STAFF REPORT

Planning Commission

November 18, 2026

Case Number	MSP-26-63 / HCPD-26-23
Request	Major Site Plan and Corridor Protection Design Review approval for construction of a ±54,948 sq. ft. grocery building and a ±10,150 sq. ft. retail building.
Property Address	3225 Patriot Parkway
Jurisdiction	City of Sumter
Tax Map #	185-00-01-105, 185-00-01-038
Current Zoning	Planned Development (PD)
Council District/Ward	5
Applicant	Patriot Parkway Realty, LLC (George A. Morgan, III)
Property Owner	Legrand of Sumter, LLC

Figure 1 - Proposed Site Plan (Sheet C2.00)

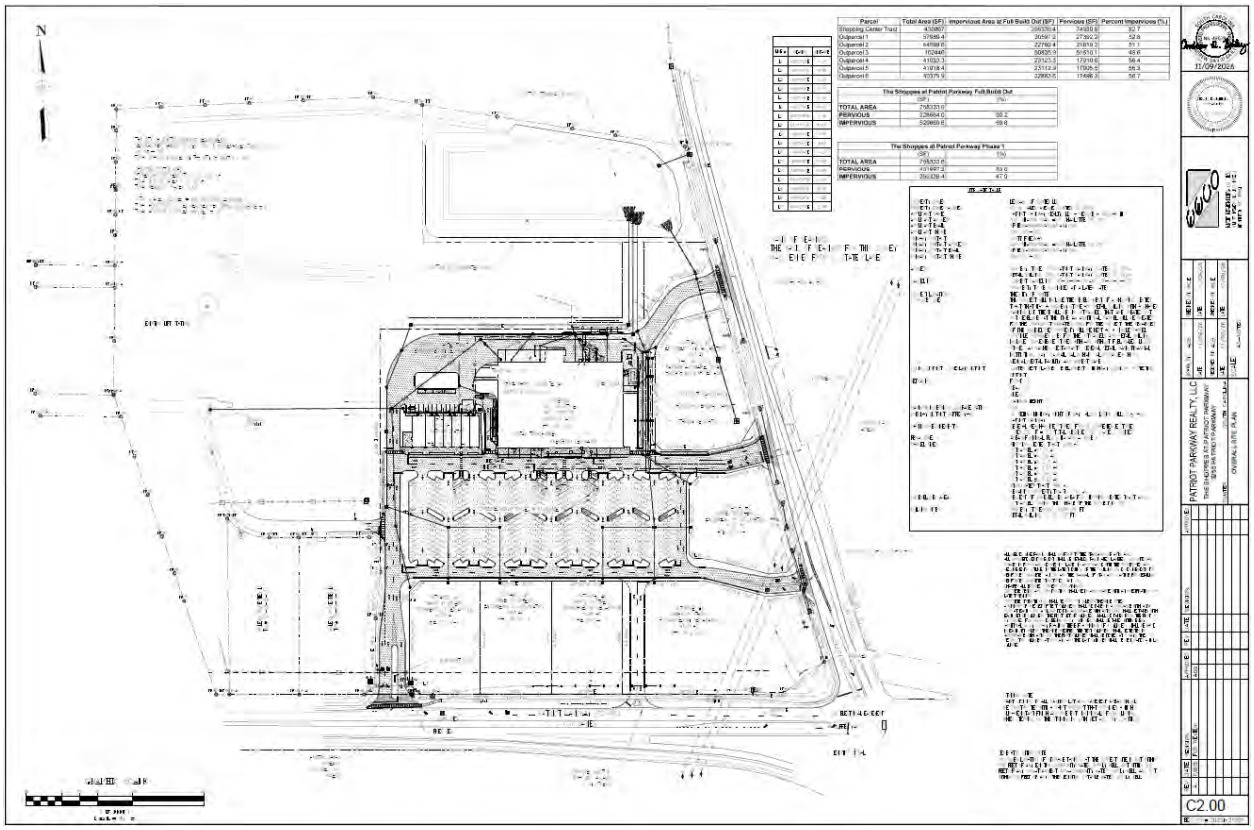
The applicant has submitted a civil engineered site plan titled "*Construction Plans for Civil Site Package The Shoppes at Patriot Parkway*" prepared by Ervin Engineering Co., Inc., last revised November 9, 2026, architectural plans titled "*Sumter Shopping Center, Loring Mill Rd. & Patriot Pkwy*" prepared by Cuhaci Peterson, last revised November 9, 2026, and landscaping plan titled "*The Shoppes at Patriot Parkway Proposed Landscape & Irrigation Documents*", prepared by MLD Studio, last revised November 9, 2026.

The site layout represents Part 1 of a 2-part development plan, with six total outparcels reserved along the site's Loring Mill Rd. and Patriot Parkway frontage for future commercial uses that are permitted by Ordinance #2914. The site's driveways, signage,

and stormwater plans are designed to accommodate the total development of the grocery store, retail building, and future out-parcel developments.

The development conforms to the concept plan dated June 30, 2026 as cited in Ordinance #2914.

Figure 4 - Proposed Freestanding Monument Signage

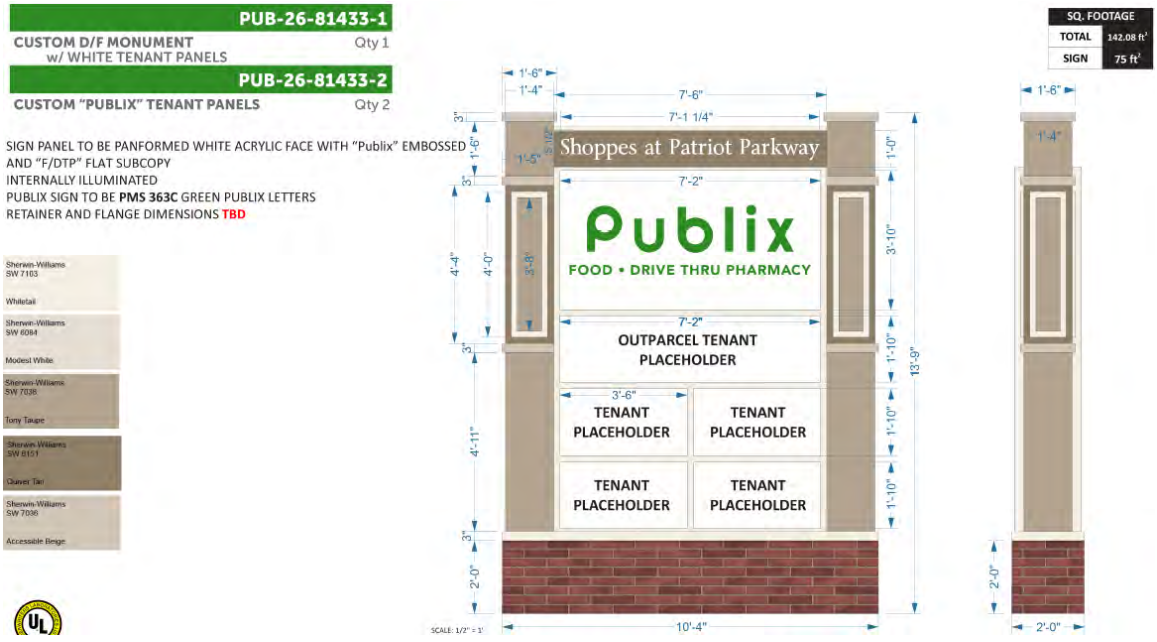
Ordinance #2914 limits freestanding signage to three monument style signs, one of which to be placed at the intersection of Patriot Pkwy. and Loring Mill Rd., and the remaining two signs to be placed at developer discretion at the entries to the site. The developer has submitted multi-tenant freestanding sign plans for both the site's driveway on Patriot Pkwy and for the center driveway on Loring Mill Rd.

With a proposed height of 13.75 ft. and total sign square feet of 142.08 sq. ft., the proposed freestanding signs are compliant with *Table C.3.1.* of the UDO.

The existing freestanding sign advertising Willie Sue's Restaurant will be removed and the signage for Willie Sue's incorporated into the Patriot Pkwy. monument sign.

Figure 5 - Proposed Landscaping Plan (Sheet L1.00)

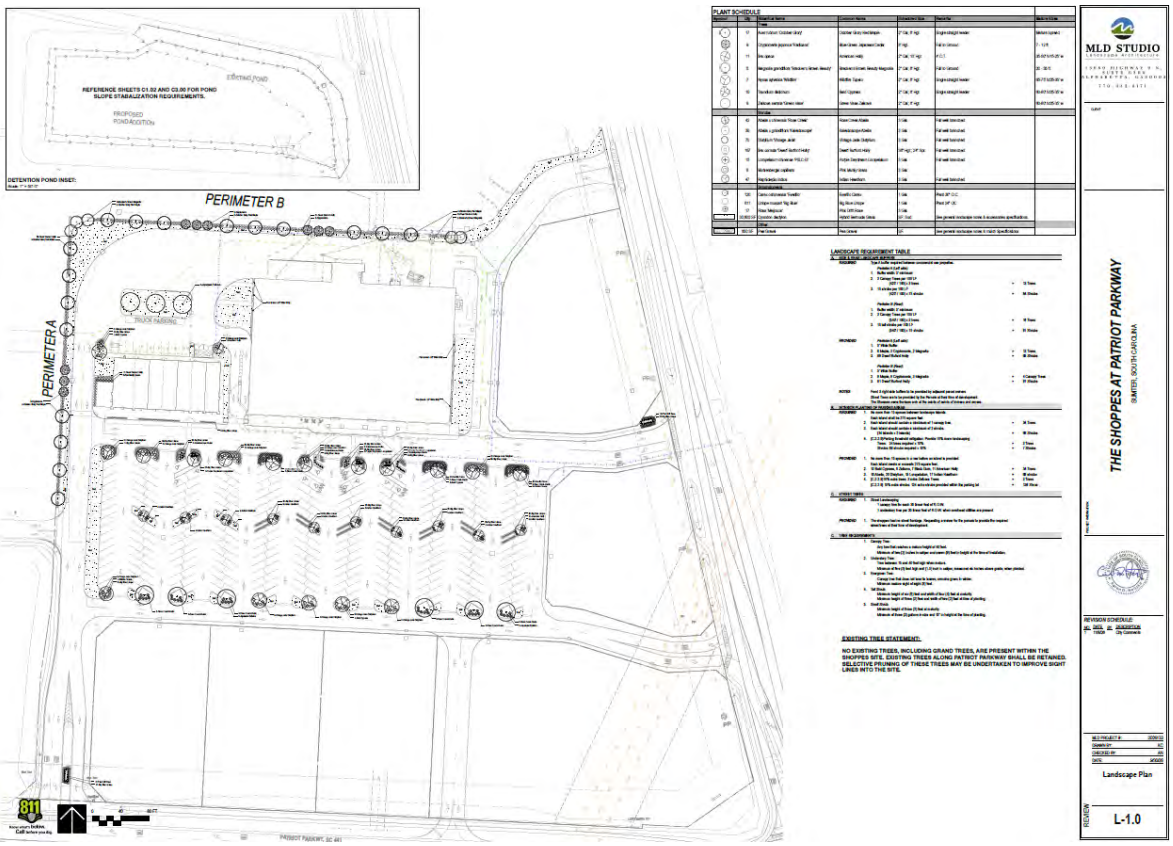
No Grand Trees, as defined in UDO Table C.5.10, are proposed for removal; no mitigation is required.

The applicant has submitted a landscaping plan compliant with the UDO that includes adequate parking lot landscaping and buffers where required. Parking lot landscaping has been increased by 10% as a mitigating design feature to meet the requirements of *Chapter C.2.2.C.9.* due to the proposed number of parking spaces.

Figure 6 - Grocery Conceptual Elevations with Material and Color Specifications

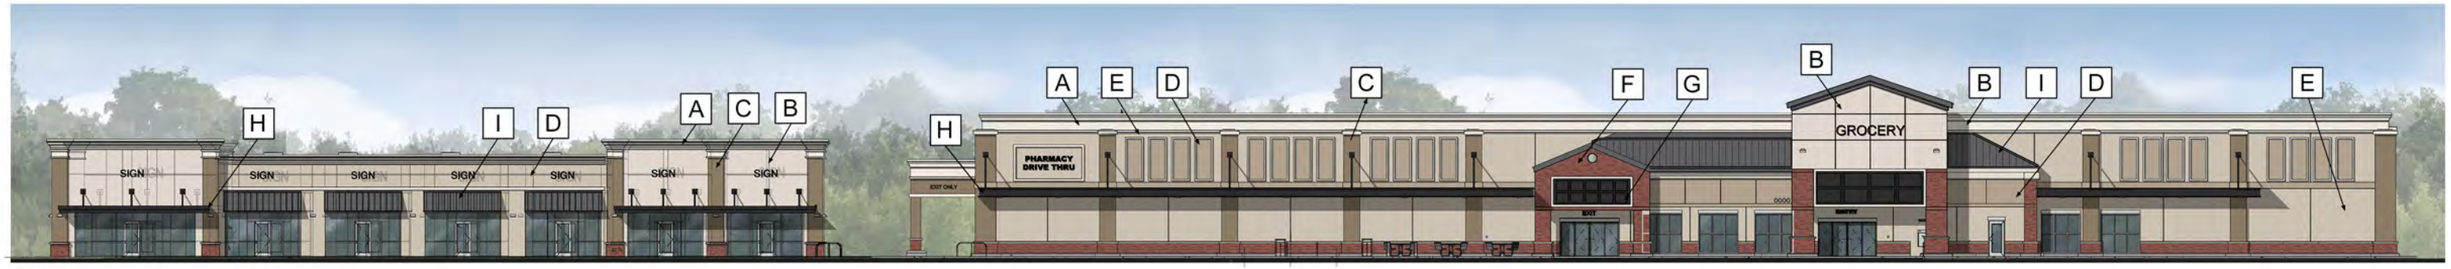
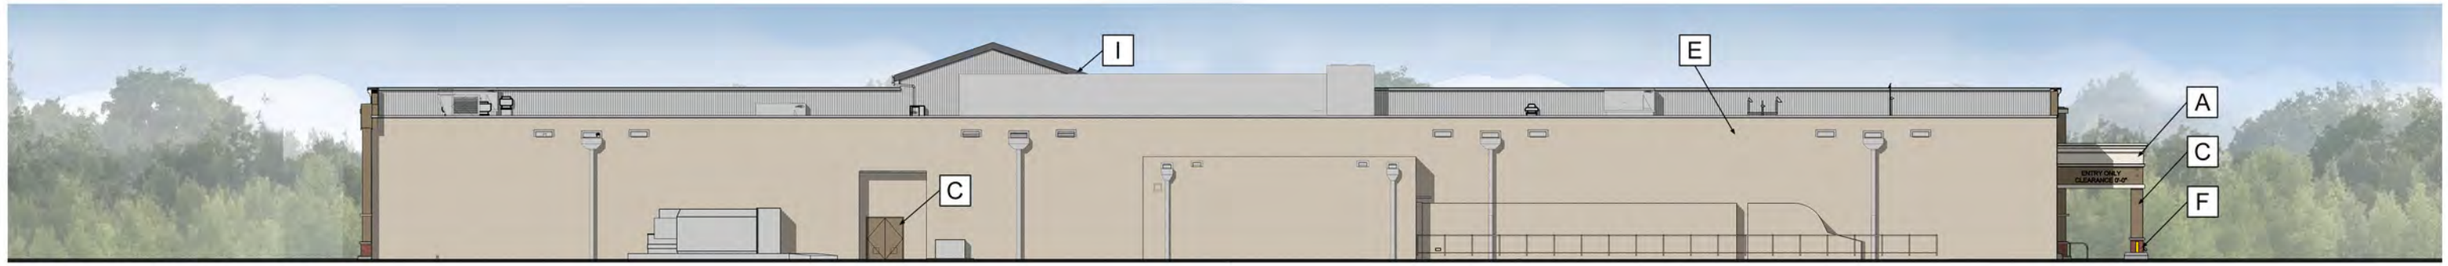
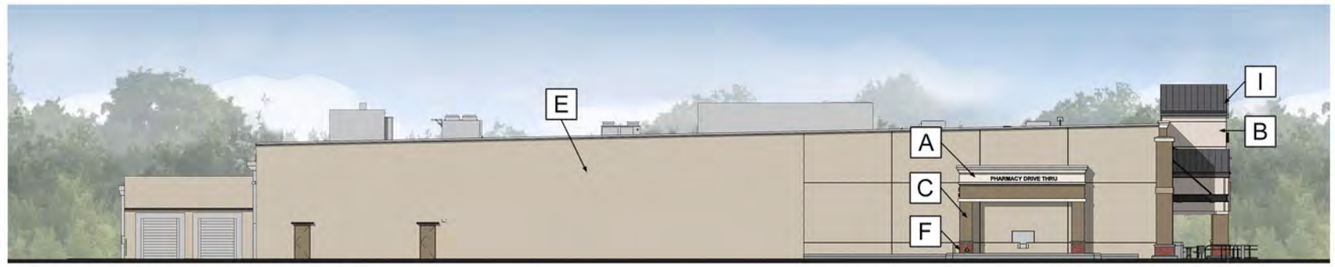
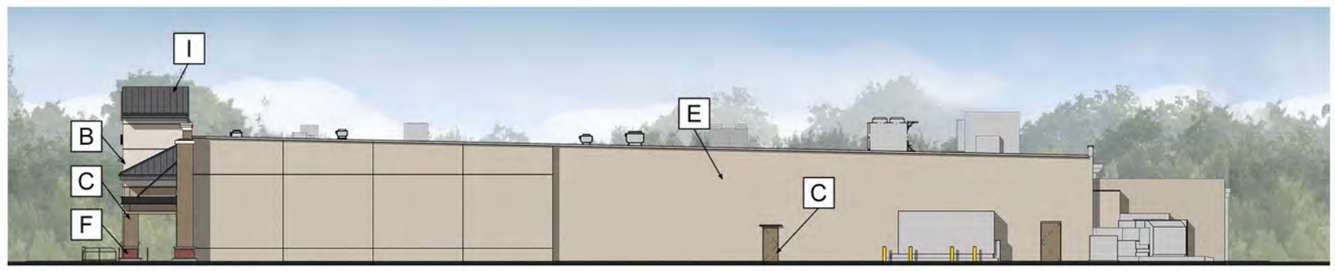
Staff Review: The proposed building complies with the required design elements of the Corridor Protection Overlay District, based on the submitted conceptual elevation and color details contained in Figure 6.
